Project Name: Barton BRO 1449(31)

Structure Identification: TH 2, Bridge 8

The precast fabrication drawings associated with Items 540.10 Precast Concrete Structure (Abutment #1), 540.10 Precast Concrete Structure (Abutment #2), 540.10 Precast Concrete Structure (Approach Slab #1), 540.10 Precast Concrete Structure (Approach Slab #2), and 900.640 Special Provision (Prestressed Concrete NEXT D Beams)(NEXT 32 D) have been reviewed and are being returned herewith.

Description of Item: Fabrication Drawings: Pre-Cast Abutments, NEXT Beams and Approach Slabs

9 ABUTMENT SECTION
 F4 3/4" = 1'-0"

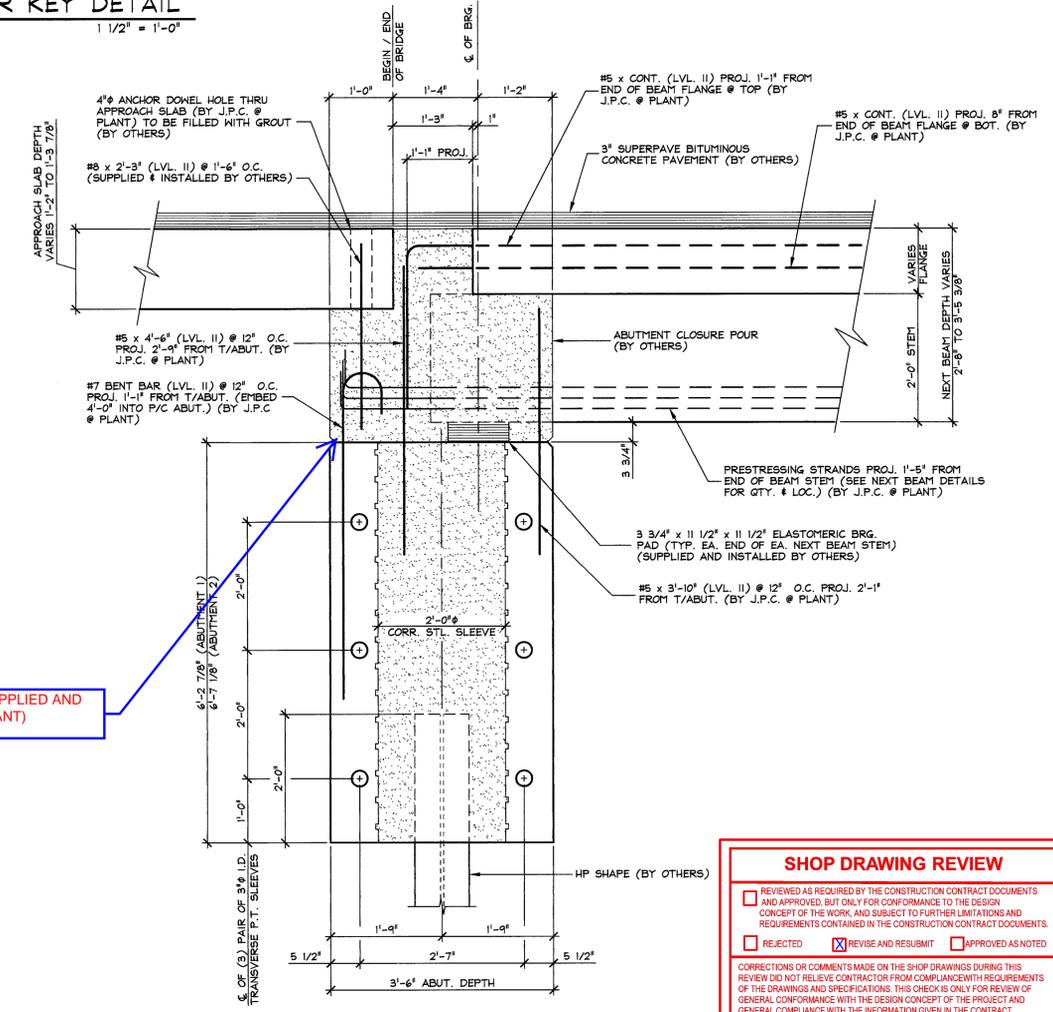
SHOW PVC WATERSTOP (SUPPLIED AND INSTALLED BY CARARRA PLANT)
